Hi-Fi Products Service Bulletin

Model: DTC-2000ES

No. 399

Subject: Fluorescent Display shuts off
Applicable Serial #'s up to 250751

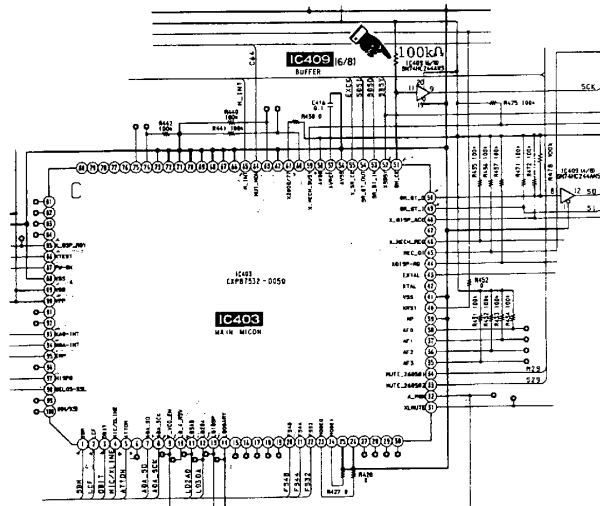
Symptom:
(13) The Fluorescent display intermittantly shuts off.

Solution: Add a 100k ohm pull up resistor (1-247-879-11) from IC403 pin 51 to +5v line. See diagram below.
